HISTORIC AND DESIGN REVIEW COMMISSION

October 07, 2020

HDRC CASE NO: 2020-390
COMMON NAME: Dawson at N Olive (three individual lots, currently unaddressed)
LEGAL DESCRIPTION: NCB 570 (OLIVE-DAWSON SUBD), BLOCK 6 LOT 23 NCB 570 (OLIVE-DAWSON SUBD), BLOCK 6 LOT 22 NCB 570 (OLIVE-DAWSON SUBD), BLOCK 6 LOT 21
ZONING: RM-4, H
CITY COUNCIL DIST.: 2
DISTRICT: Dignowity Hill Historic District
APPLICANT: Ron Alvarado/AG Associates Architects
OWNER: Douglas Miller/DM Dirt, LLC
TYPE OF WORK: Construction of three, 2-story residential structures
APPLICATION RECEIVED: August 31, 2020
60-DAY REVIEW: Not applicable due to City Council Emergency Orders
CASE MANAGER: Edward Hall

The applicant is requesting conceptual approval to construct three, 2-story residential structures on the vacant lot at the corner of Dawson at N Olive, located within the Dignowity Hill Historic District. These lots are currently unaddressed.

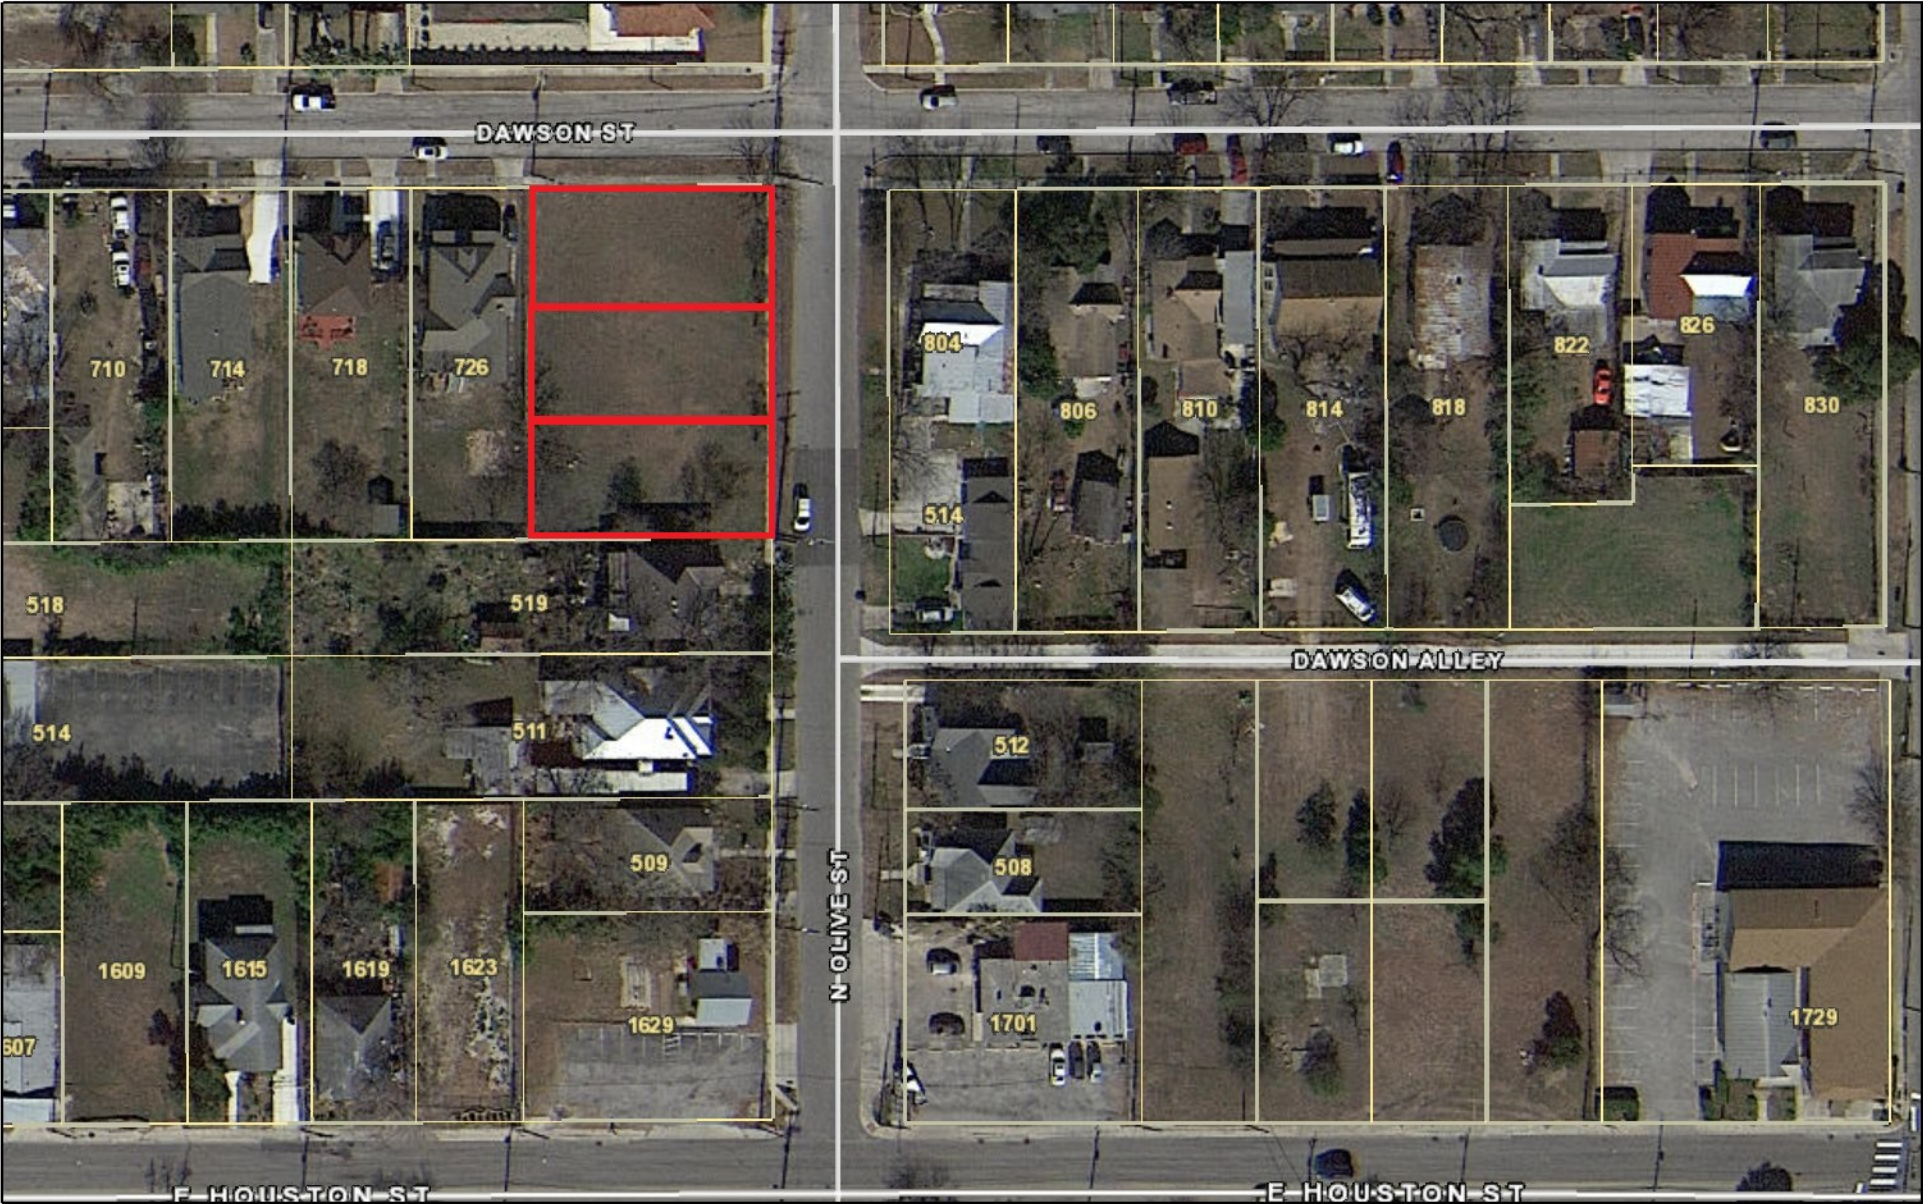
- g. **SETBACKS & ORIENTATION** – The applicant has proposed for the new construction to feature setbacks that exceed those found historically on both Dawson and N Olive. This is inconsistent with the Guidelines for New Construction. Regarding orientation, as noted in finding c, houses found historically on Dawson Street on corner lots feature an orientation toward Dawson. The proposed orientation toward N Olive is inconsistent with the Guidelines and historic development pattern found within the district. Staff finds that the proposed new construction should feature a setback that is equal to or greater than those found historically on the block and that the multiple structures should be re-oriented toward Dawson.

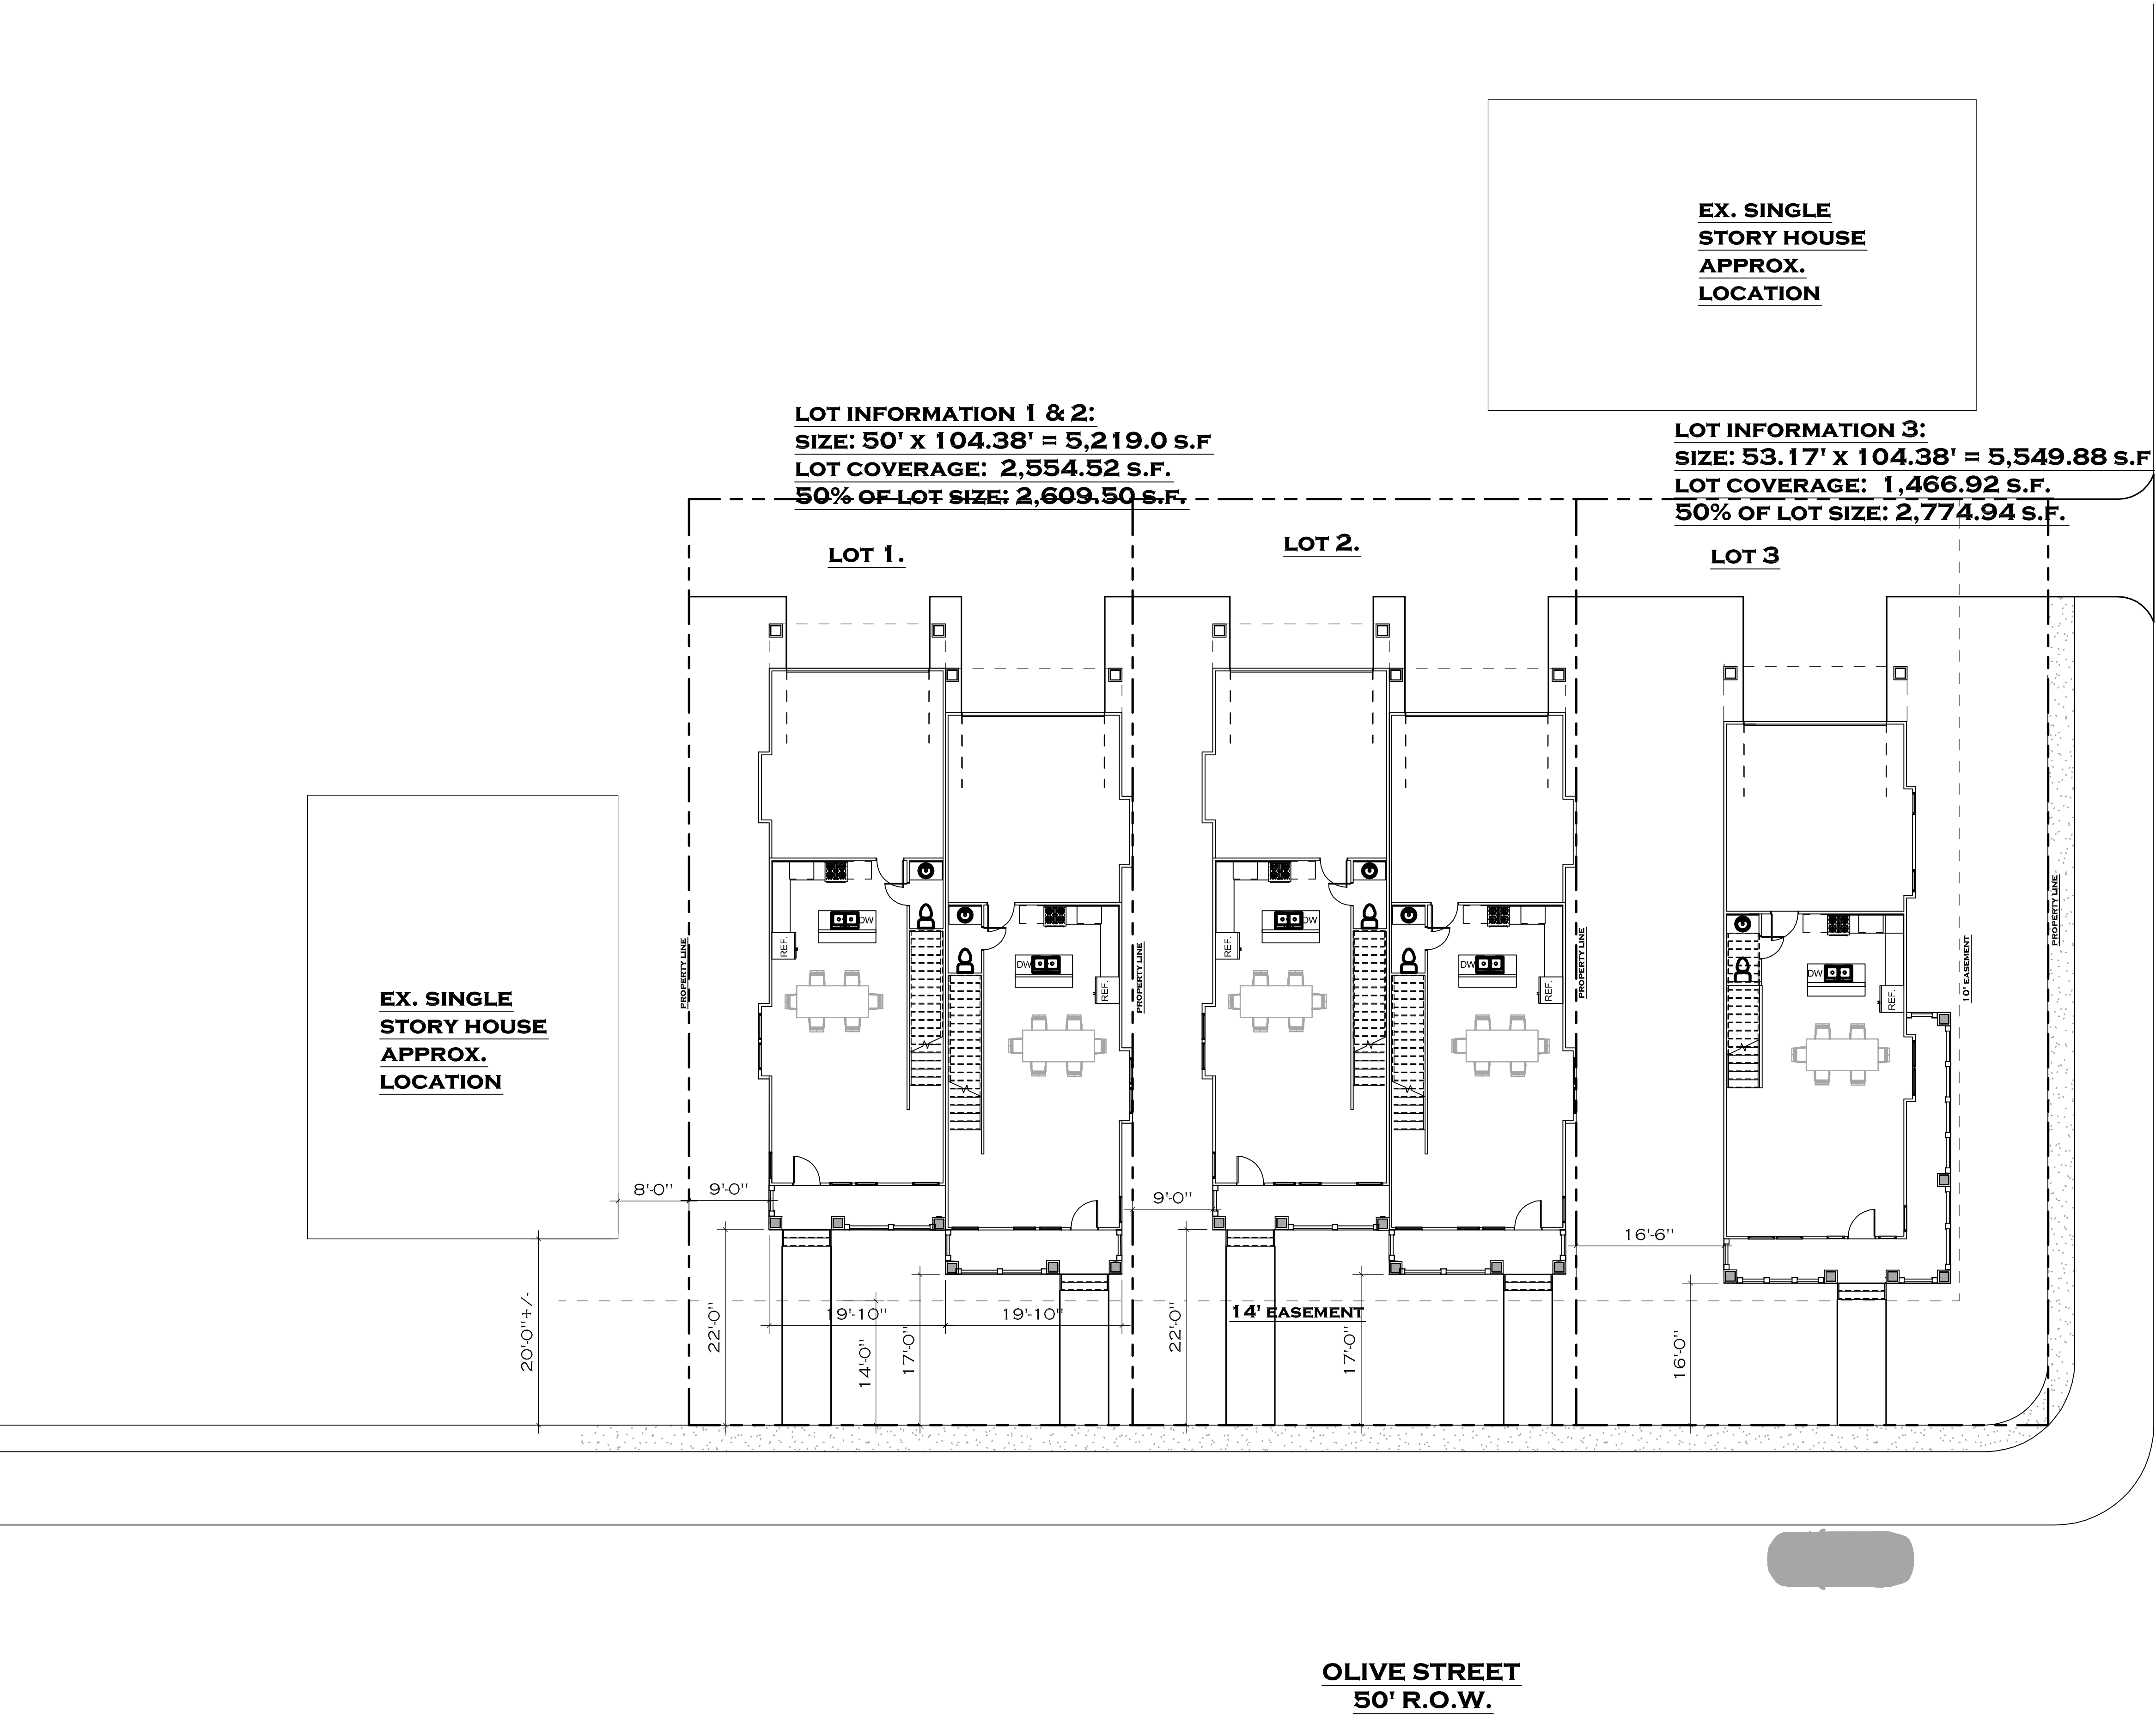
- vi. That the proposed building spacing be increased as noted in finding l.
RESPONSE: Please refer to the revised site plan. The plan shows that the building spacing has been increased

RESPONSE: the setbacks for the new structures have been revised and can be seen in the revised Site Plan. Although the corner lot, along with the other two lots are not addressed. The corner lot does have an orientation facing N. Olive Street and Not Dawson Street. To re-plat the corner lot will make the project unfeasible which would result in not moving forward with project.

RESPONSE: the revised Site Plan illustrates via calculations that each dwelling do not exceed the 50% lot coverage. According to the HDRC guidelines the 50% is stating that the building footprint is to be used for the calculations which do not include paving areas.
